## Change Notification

**4M3F Change No.: PCN261011HB**

All FN28x-xx-06 (all single fuse versions)

Change: New fuse holder with extra holder for spare fuse.

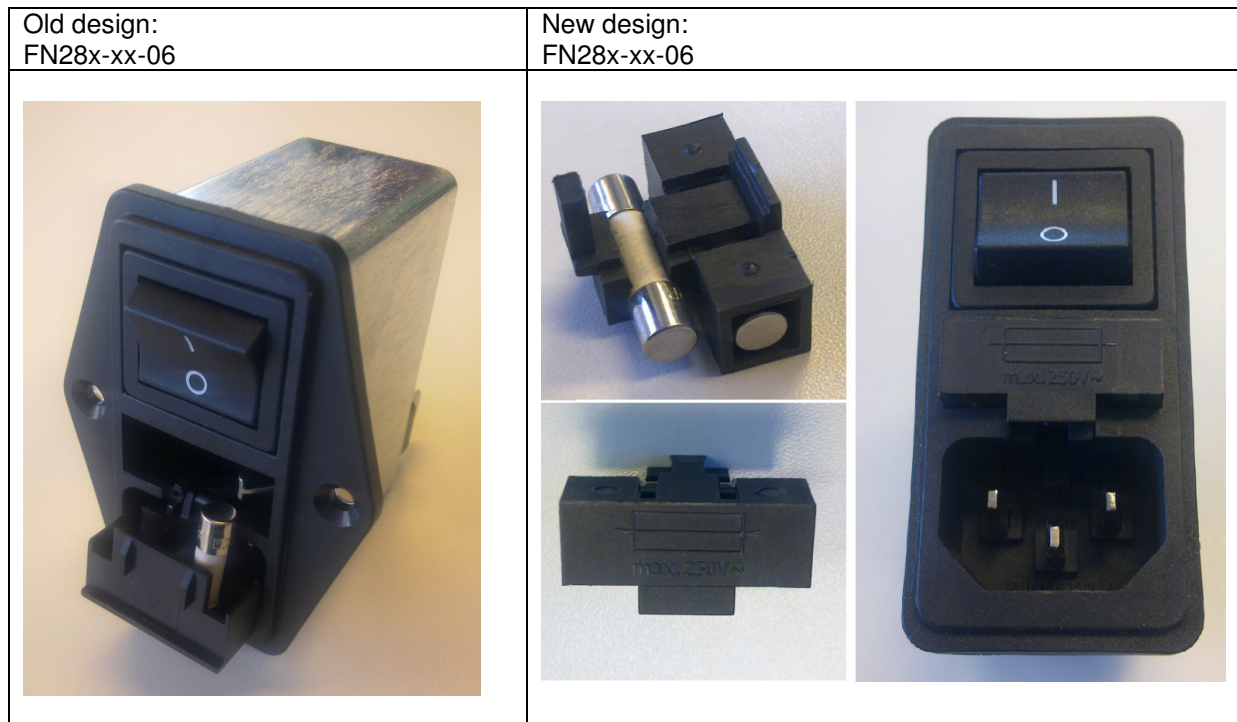
Outer appearance and size remains unchanged. The fuse holder and the internal construction was reworked. It fulfills shock safe category PC2. The fuse holder can be completely pulled out now and contains an extra holder for a spare fuse.

When pulled out the fuse is now located horizontal across the power entry module instead inward-looking like before (see pictures).
